**APPENDIX A
DRB MARCH 11, 2019**

Potrero Power Station Mixed-Use Redevelopment
Responses to April 9, 2018 DRB Comments

FIGURE 4-19-1 Outdoor Food Service Areas at Waterfront Park

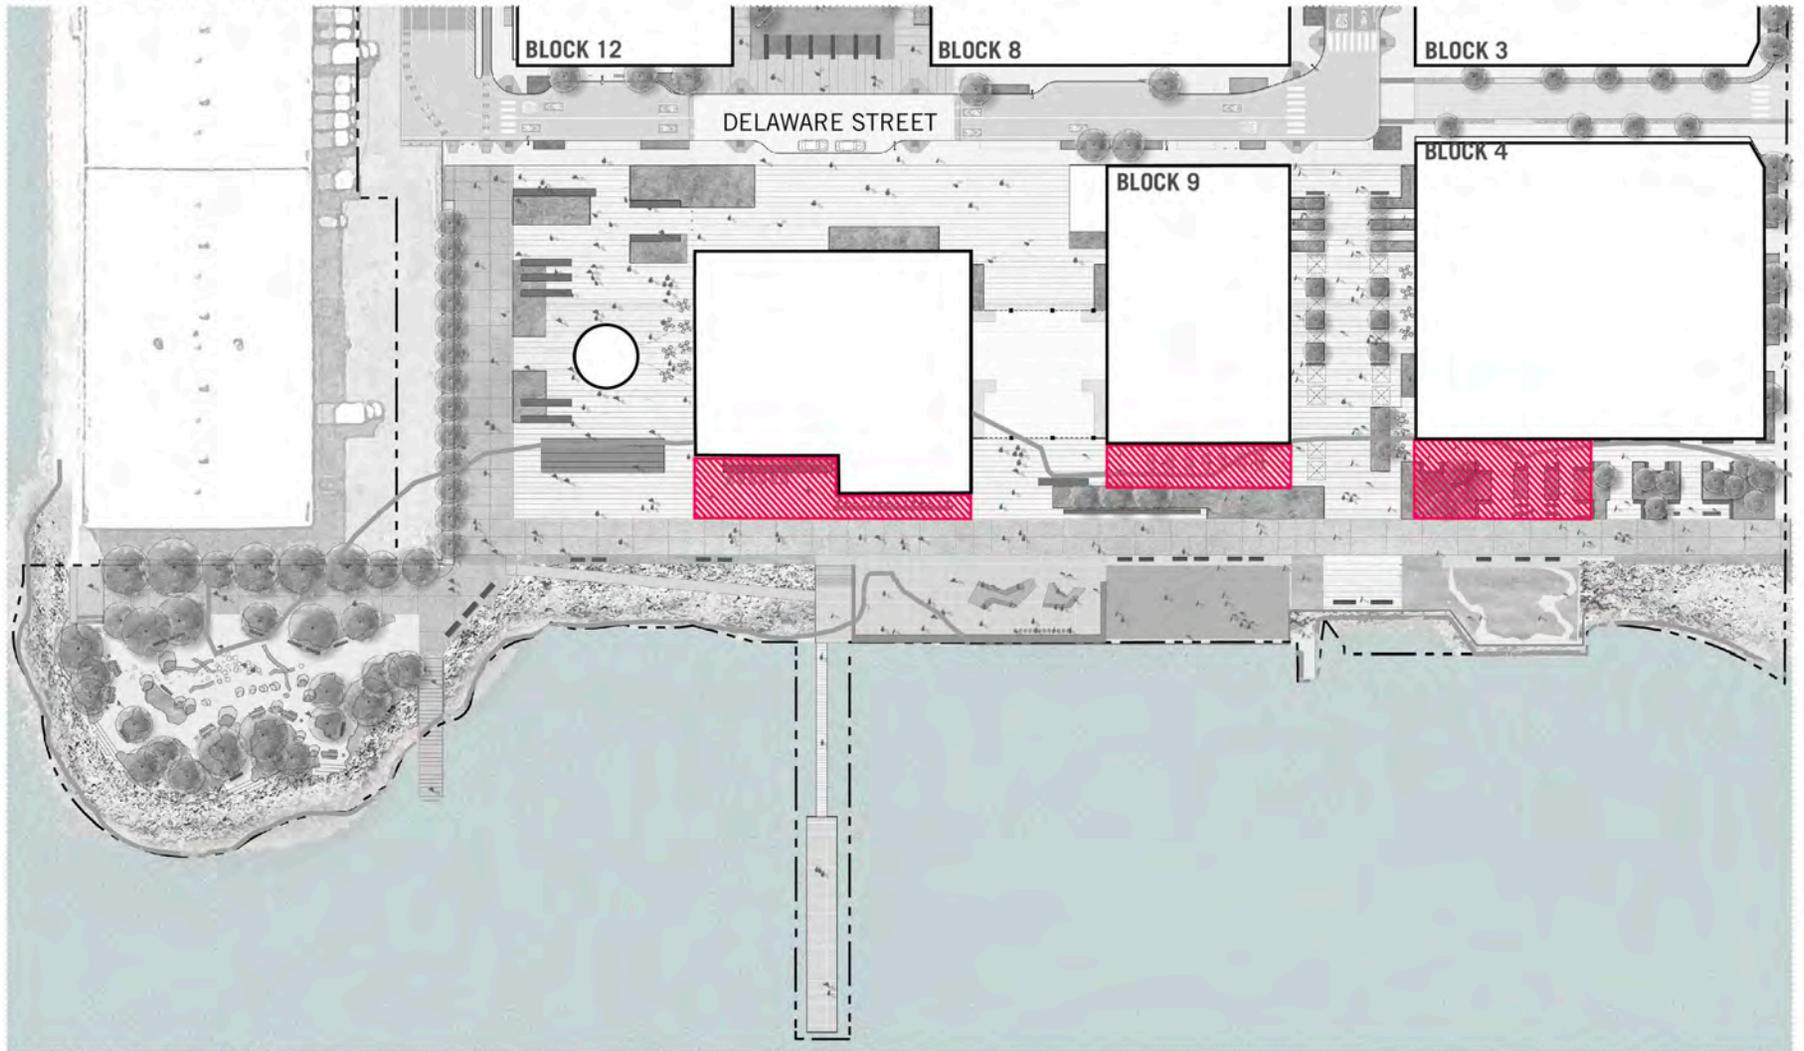
DRB SUMMARY AND CONCLUSIONS	
Physical and Visual Access:	Project Sponsor Response
(1) Ensure that the spaces adjacent to the buildings feel public.	We have carefully considered the publicness of spaces adjacent to buildings, and require that at least 40 percent of the seating areas adjacent to eating establishments remain open to the public, without a requirement for patronage of eating / drinking establishments. This is a requirement stated in our Design for Development document, as shown in the attached excerpt (Attachment 1).
